ATTACHMENT 1

PROPOSED AMENDMENT TO LCO 4.1.9

LCO 4.1.9 ANALYSIS

LCO4.1.9 REANALYSIS

Figure 4.1.9-1

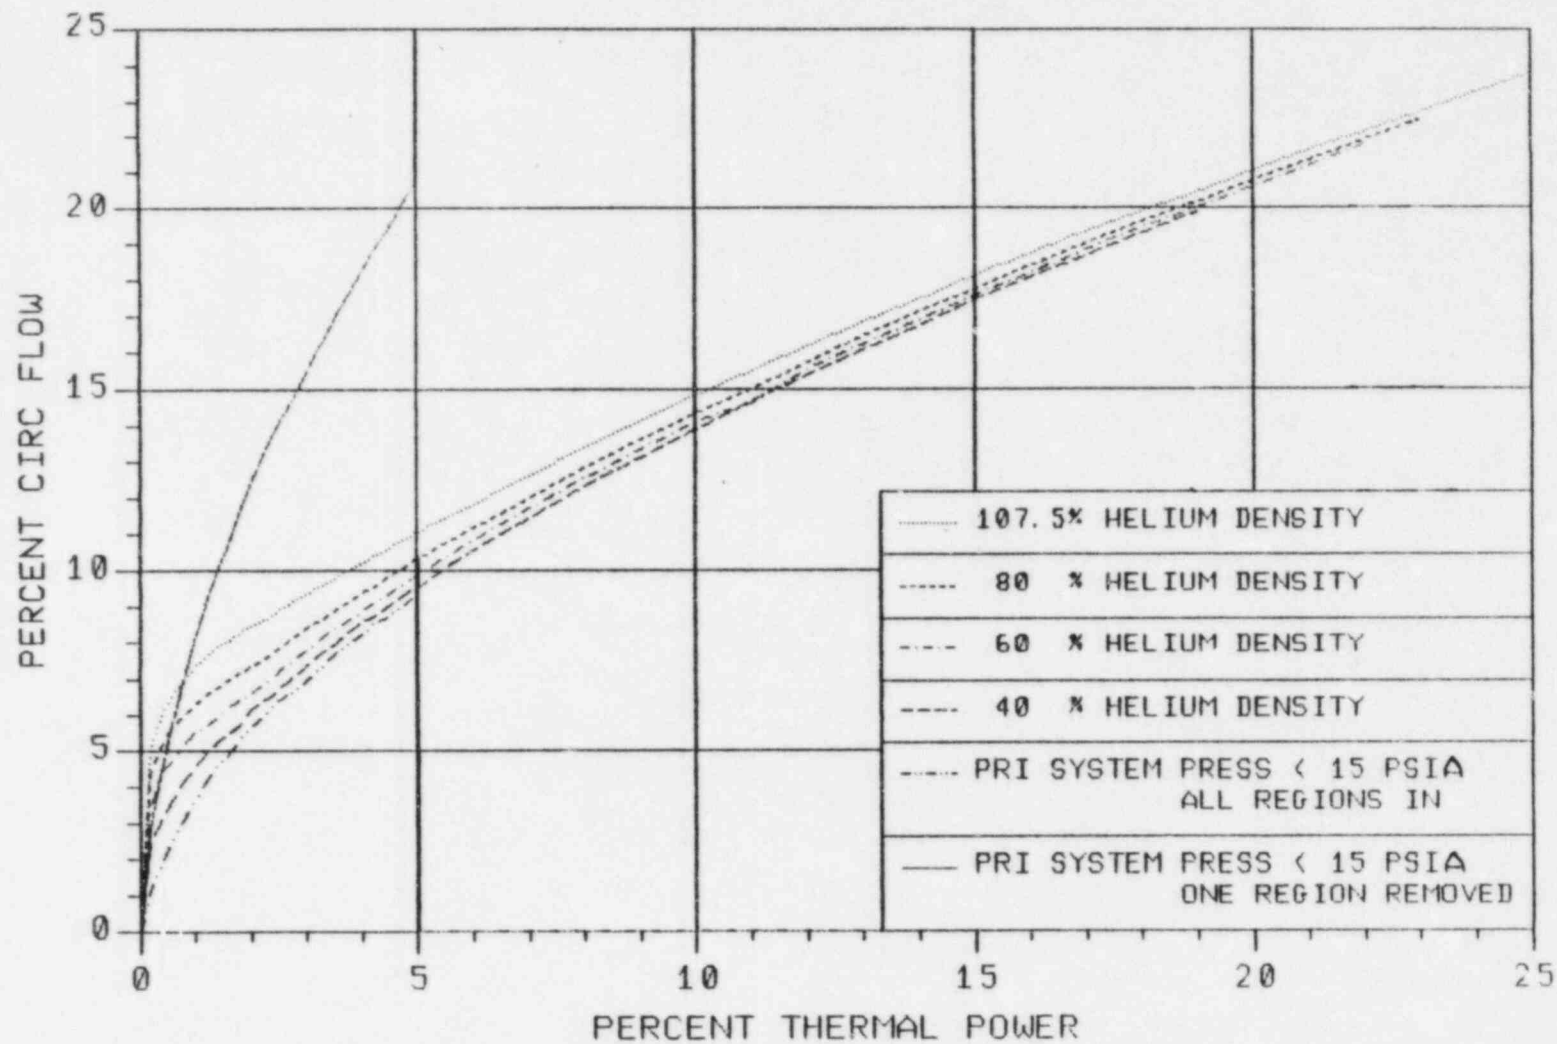
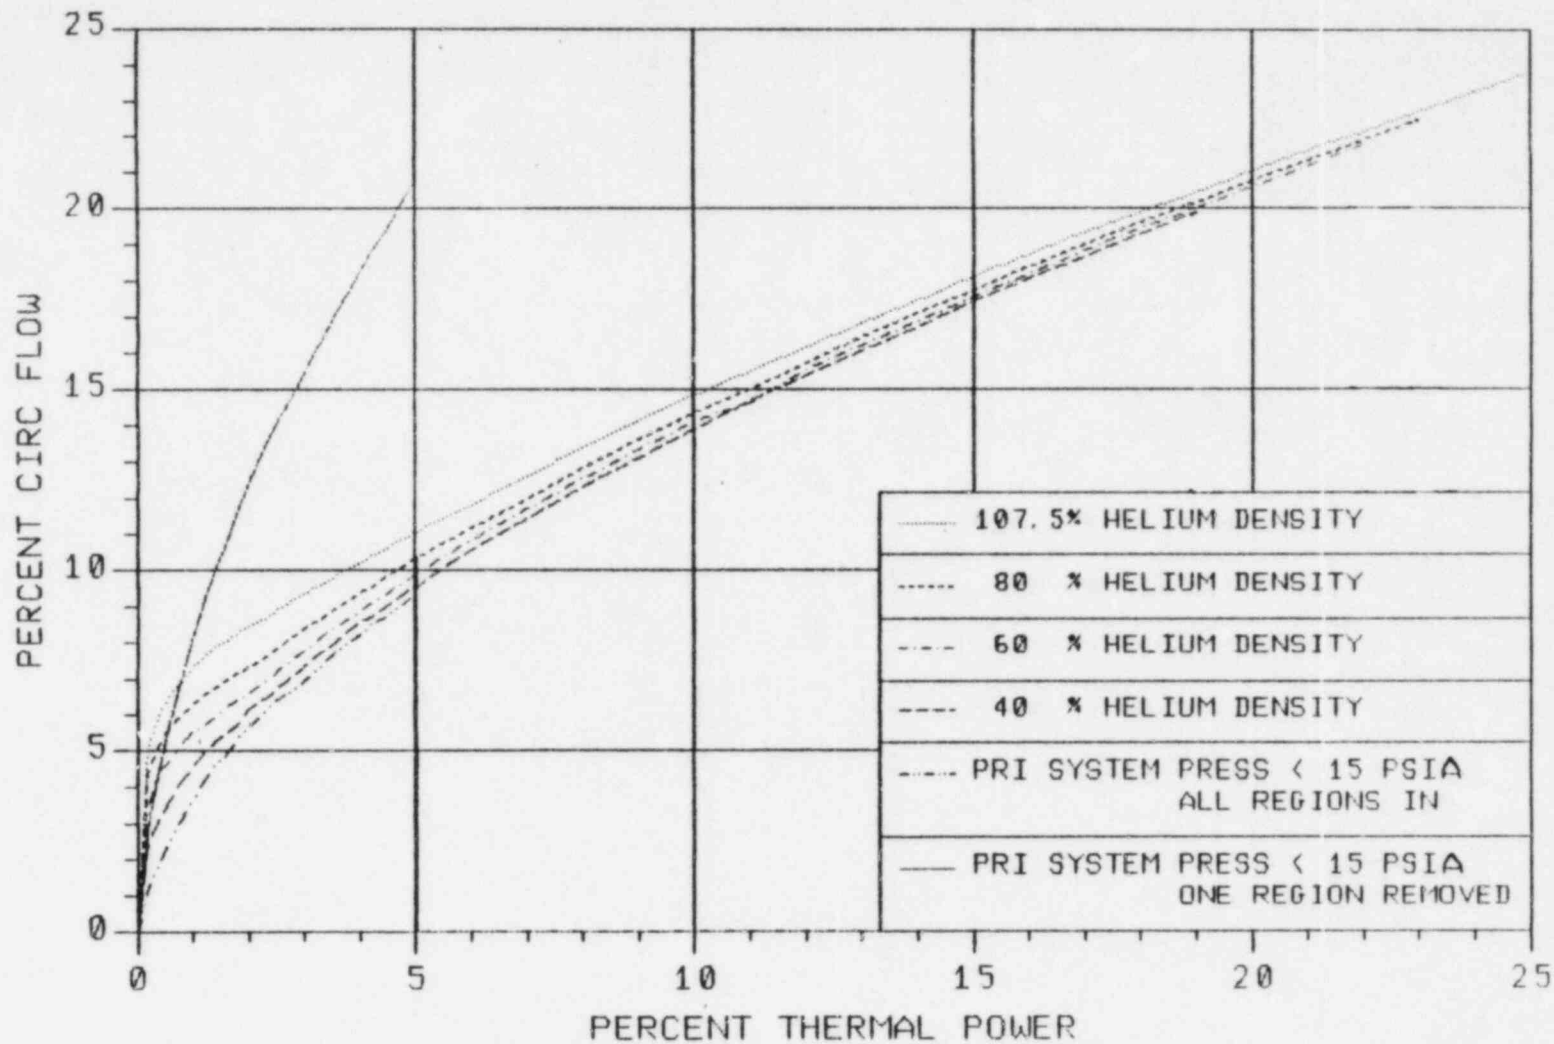
Whenever core inlet orifice valves are set for equal region flows, the total circulator flow rate shall be above the minimums given in Figure 4.1.9-1 (at the appropriate helium density and power level). Whenever the core inlet orifice valves are set at any positions other than for equal region flows, the measured helium coolant temperature rise through any core region shall not exceed the limits given in Figure 4.1.9-2 (at the appropriate helium density and power level).

Proposed new limits for LCO 4.1.9 are shown in Figures 1 and 2. The changes that have been made are enumerated below:

1. The effect of different density gases in the upper and lower reflectors has been accounted for. It was thought that this term had been included in the original analysis (see equation 3 of Reference 4). However, based on a recent review of the original analysis, it appears that this term had been omitted (Reference 6). Note also that the gravity term in this equation is slightly in error (Reference 7). The correct term is given in the next section.

2. The maximum column to region average power peaking factor (TILT) was increased from 1.44 (used in the original analysis) to 1.61, to be consistent with the limit given in LCO 4.1.3 of the Fort St. Vrain Technical Specifications.

3. The number of coolant holes in the core was increased from 23,550 to 24,133. The calculation for the number of coolant holes is given in Appendix A.

4. The analysis was performed at the maximum permissible primary coolant inventory of 107.5% specified in LCO 4.4.1 of the Technical Specifications. The original analyses had been performed at nominal coolant inventory.

Since the proposed amendment to LCO 4.1.9 serves to define new operating limits which correct for non-conservative errors and omissions in the development of the original limits, operation of the facility in accordance with the proposed amendment will not (1) involve an increase in the probability or consequences of an accident previously evaluated, (2) create the possibility of a new or different kind of accident from any accident previously evaluated, or (3) involve a reduction in a margin of safety. It is therefore concluded that the proposed amendment involves no significant hazards considerations.

Figure 4.1.9-2

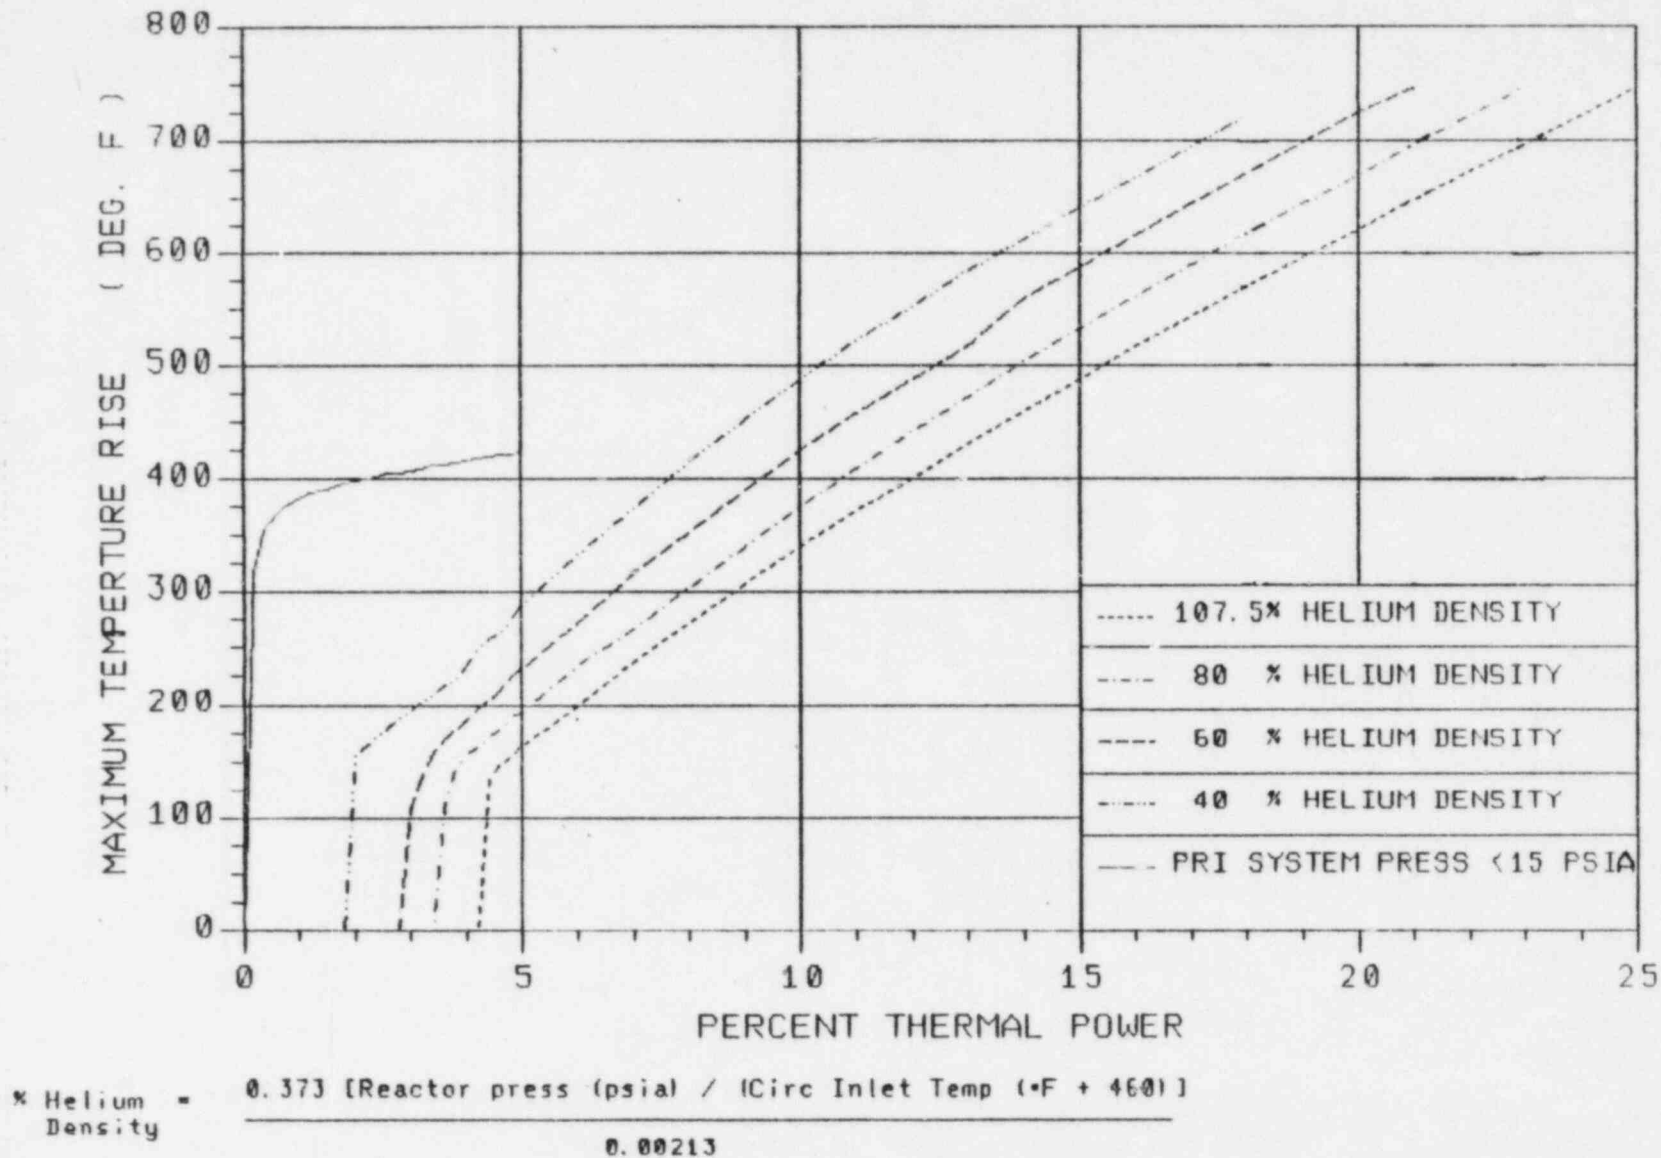
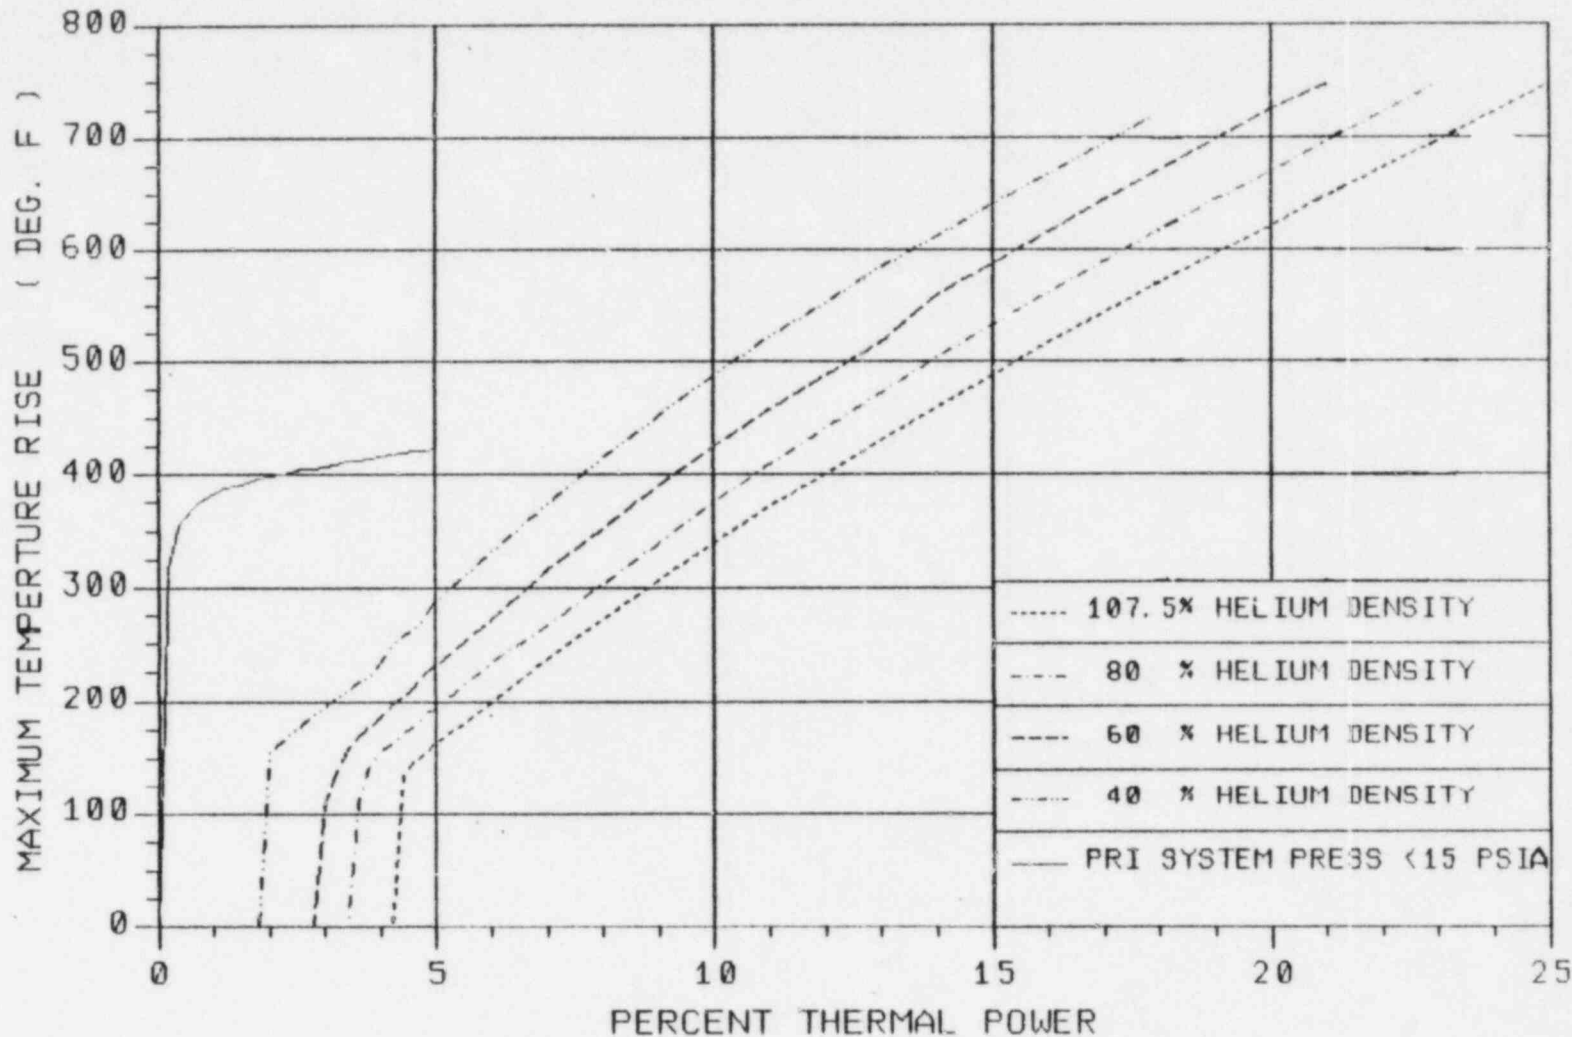
9. Relationships were developed to account for uncertainty in these models and measurement errors, which were factored into the analysis. These relationships are also developed in Appendix A. Estimates for uncertainty in the various parameters are given in Table 1. The uncertainty estimates are believed to be conservative, given the considerable operating experience at Fort St. Vrain. In the previous Figure 1 limit (core flow vs. core power) the minimum core flow had been increased by 25% as a factor of conservatism. This factor is larger than that obtained from the uncertainty analysis, by -10% to 15%. In the previous Figure 2 limit no factor of conservatism had been used.

FIGURE 1. LCO 4.1.9-1

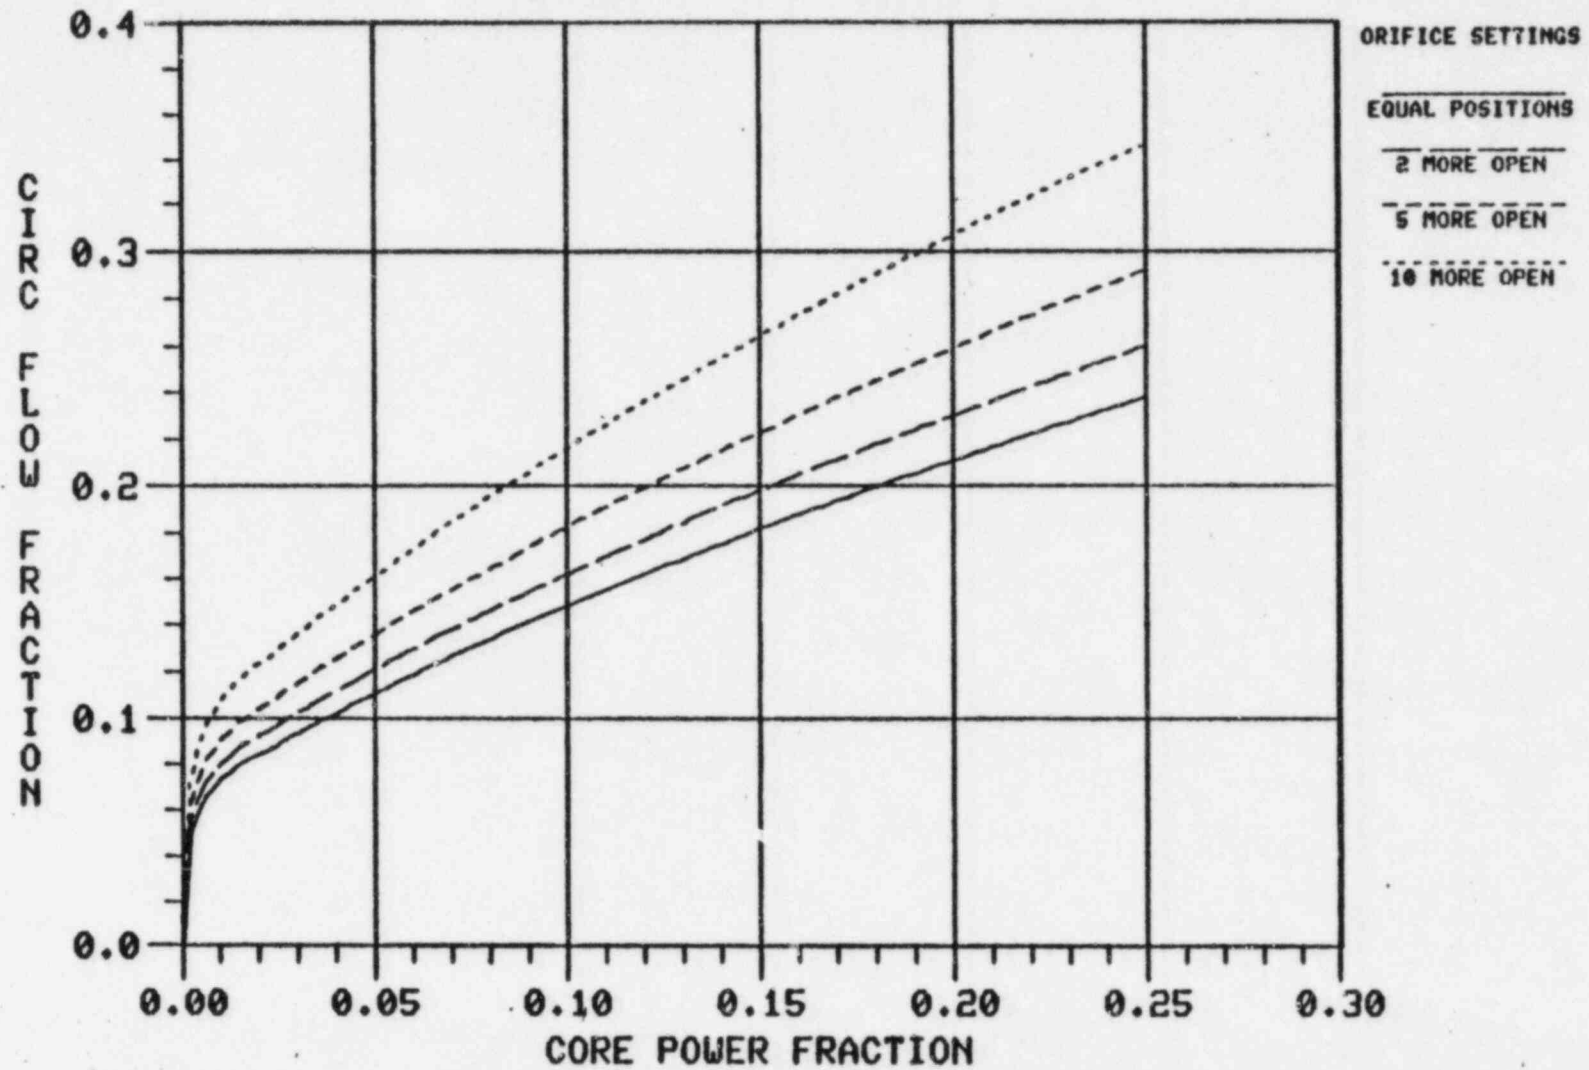
The curves in Figures 1 which permit the orifices on some regions to be more open than the others were generated using methods described in References 1 and 2 (some of the factors were available from these references and taken directly). These factors are given in Table 3. An orifice setting of 8% open for 7-column regions was assumed in developing the Figure 1 curves where some orifices are more open than the uniform flow positions. The Figure 1 curves are then valid for uniform orifice settings of 8 - 20% open.

FIGURE 2. LCO 4.1.9-2

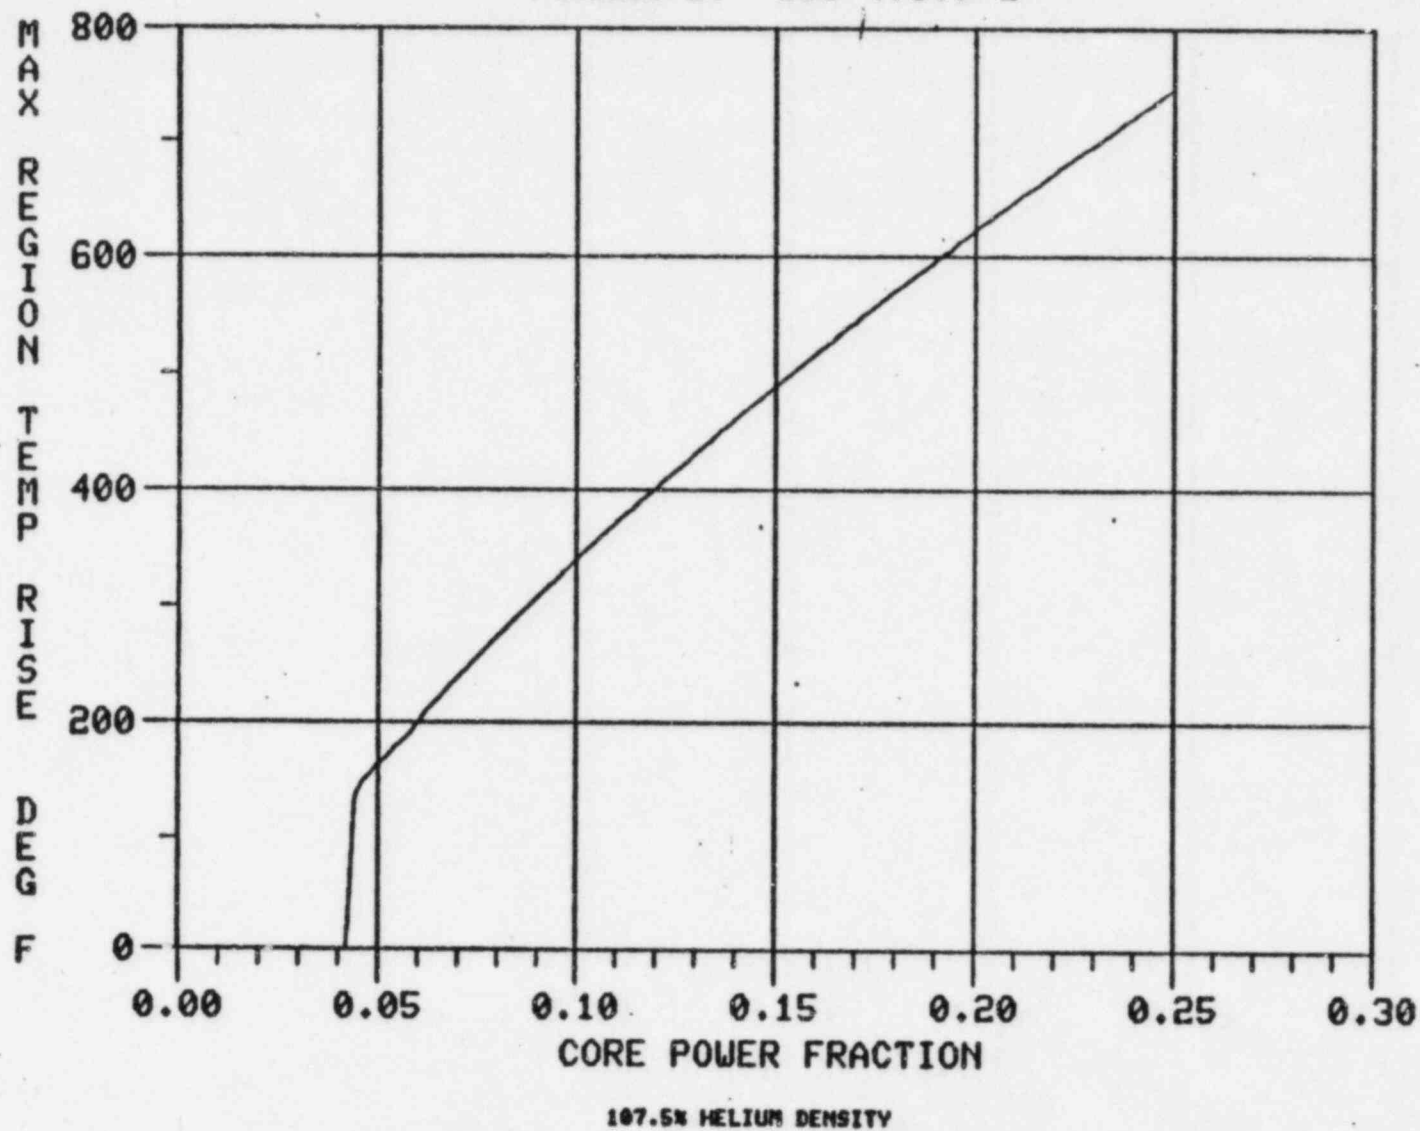
The core bypass flow fraction for the 20% open orifice position case was also used in the analysis for the LCO 4.1.9-2 limit. This case was used because, due to the limited range of flow control of the orifices, closing the orifices beyond 20% open leads to core flow resistances where the low power (critical) region is necessarily overcooled.
